**RE: New Heart Parking Expansion
Grading and Drainage Plan
Engineer's Stamp Date: 10/09/18
Hydrology File: J15D051**

Based upon the information provided in your submittal received 10/10/18, the Grading and Drainage Plan **is not** approved for Building Permit and for action by the DRB on the Final Plat. The following comments need to be addressed for approval of the above referenced project:

Supplemental Information for New Heart Parking Improvements

NEW HEART PARKING EXPANSION NEW HEART CENTER FOR WELLNESS			
GRADING & DRAINAGE PLAN			
Date: 10/09/18	No. Revision:	Date:	Job No. 2206
Drawn By: BJB			CG-101
Ckd By: FCA			SH. OF

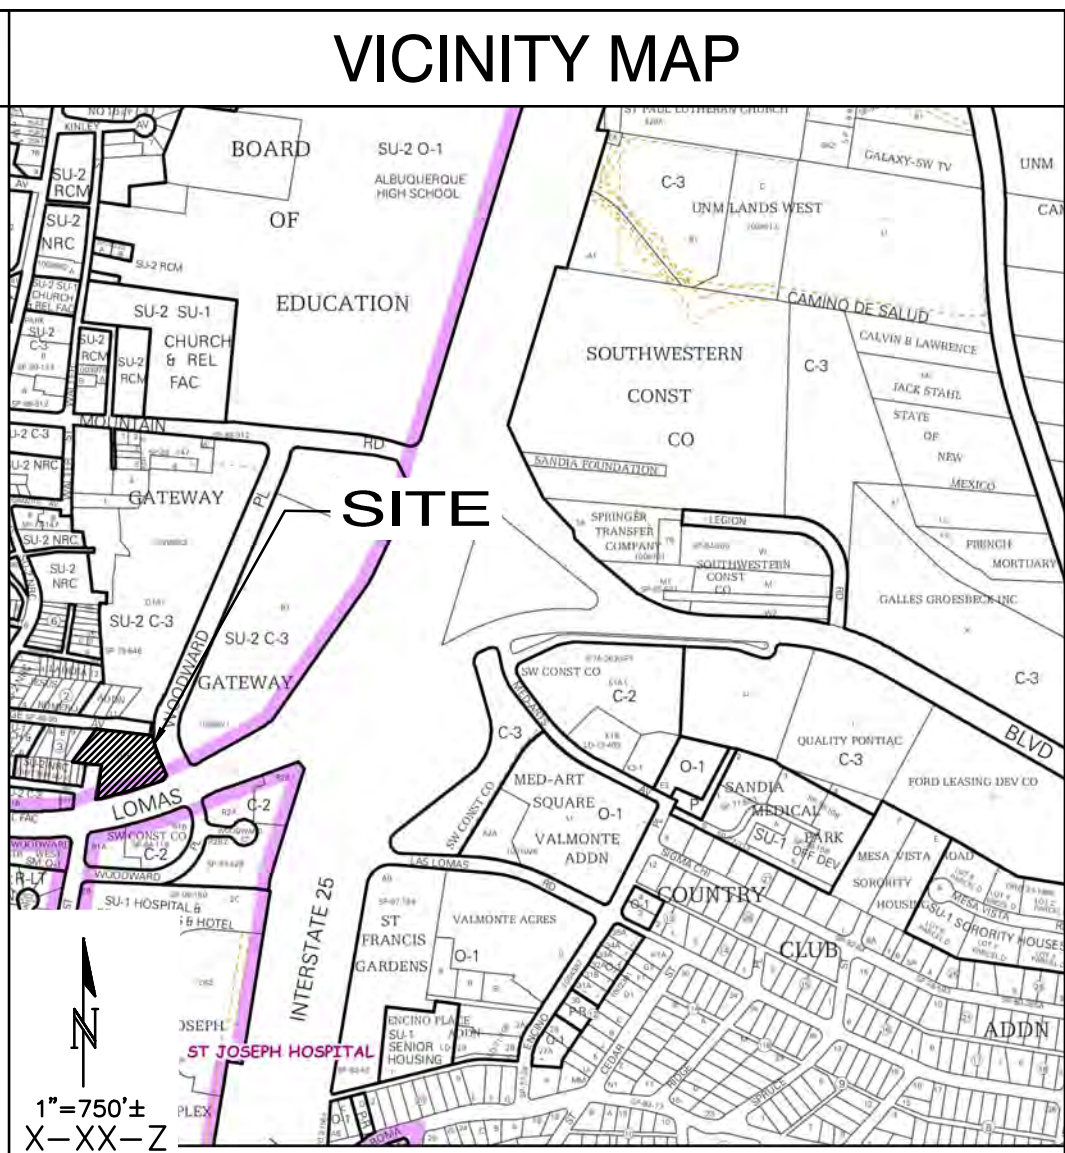
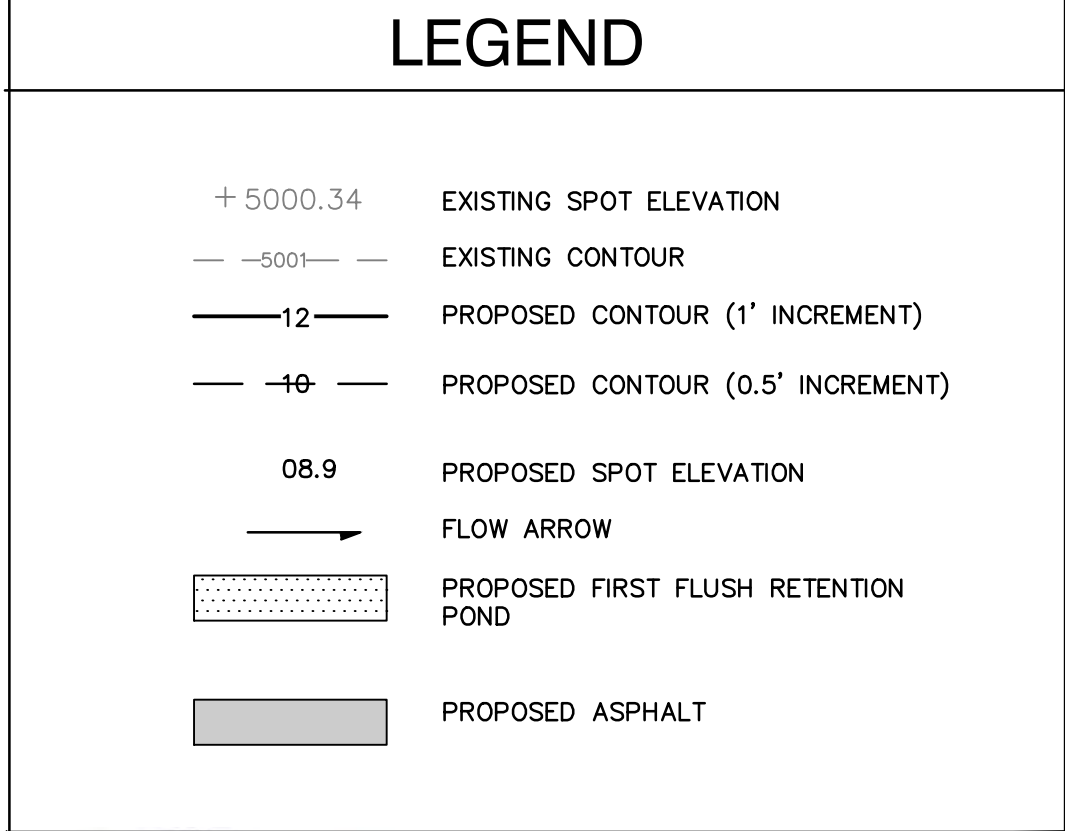
2. Please Add a section of the proposed garden wall between Tract D-1-B-2 and Tract D-1-B.

3. And get written permission from the adjacent property owner for the footer and the wall to be placed along the property line. I think you mentioned that they were the ones who wants the wall. Per DPM Ch. 22.5.B, grading and construction of retaining walls at or near the property line must demonstrate that the adjacent property is not damaged or its use constrained. Any such encroachment by the wall or grading must be accompanied by written permission of both landowners.
